NOTICE OF ALTERATIONS/MODIFICATIONS

Our Ref.: AVG-04-C025

Name of Appliance: Portable DVD/CD Player

Model No(s): DVD-LS55

Copper Foil covered FPC

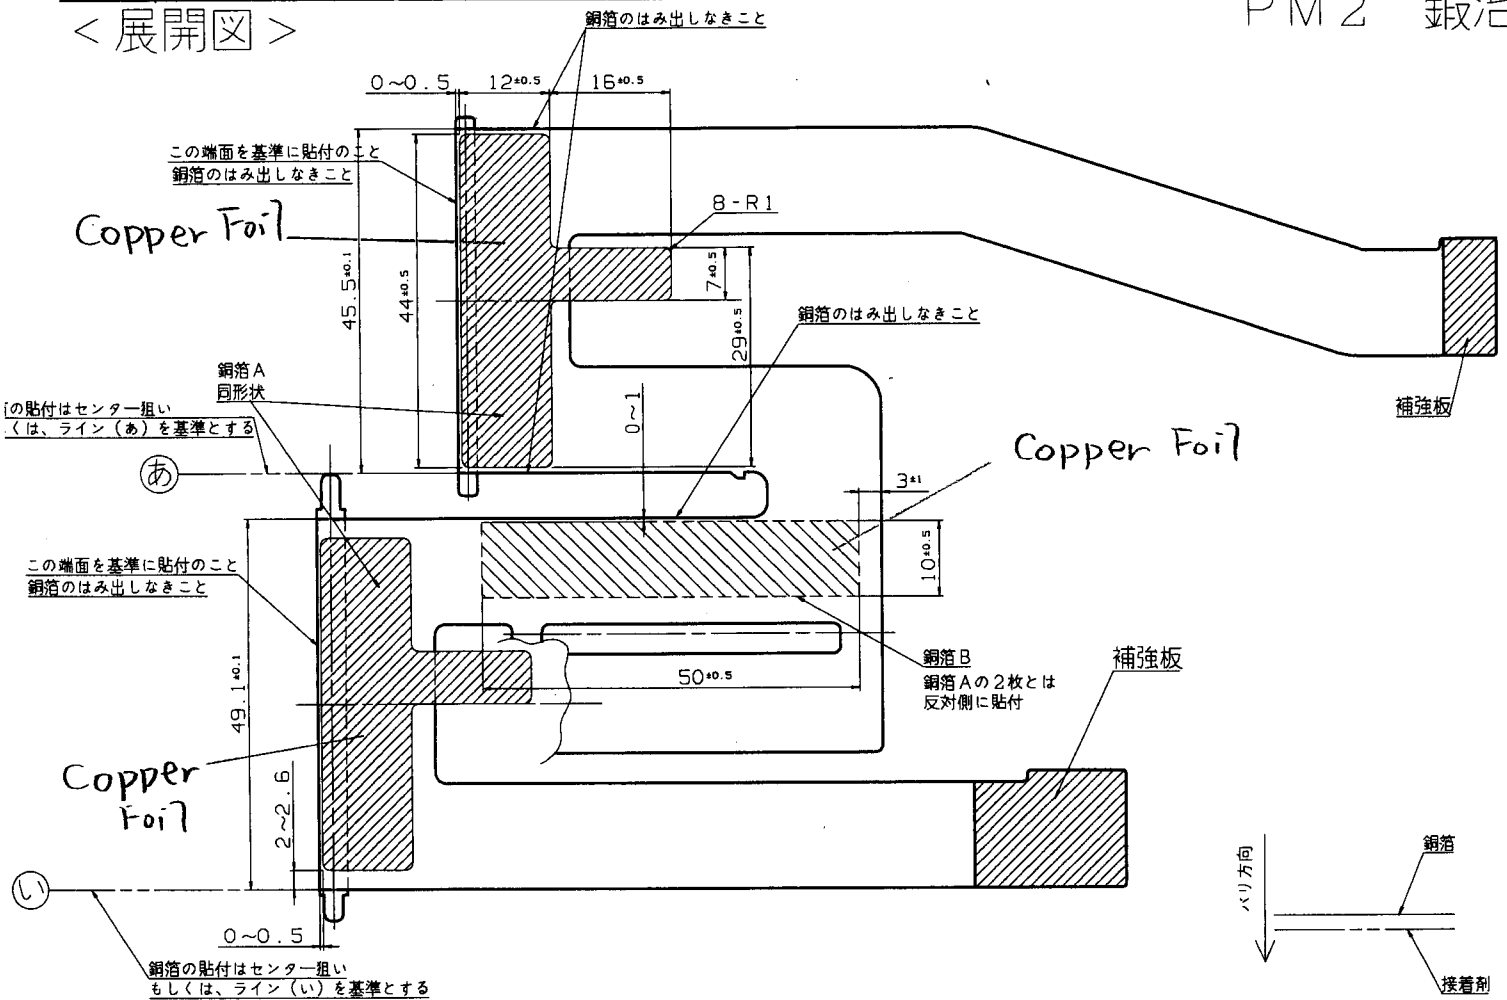
METHOD PRESENTLY EMPLOYED	PROSPECTIVE CHANGE
<p>1.</p> <p>1) None</p>	<p>1. Adding following components to the FM transmitter circuit .</p> <p>1) Chip resistors Circuit No. : R4909 Rating : 33 Ohms 1/10 W</p> <p>Circuit No. : R4910, R4911 Rating : 330 Ohms 1/10 W</p> <p>Please refer to the revised schematic diagram we attached.</p>
<p>2.</p> <p>1) None</p>	<p>2. Adding copper foils to the FPC .</p> <p>1) Please refer to photos and drawing.</p>
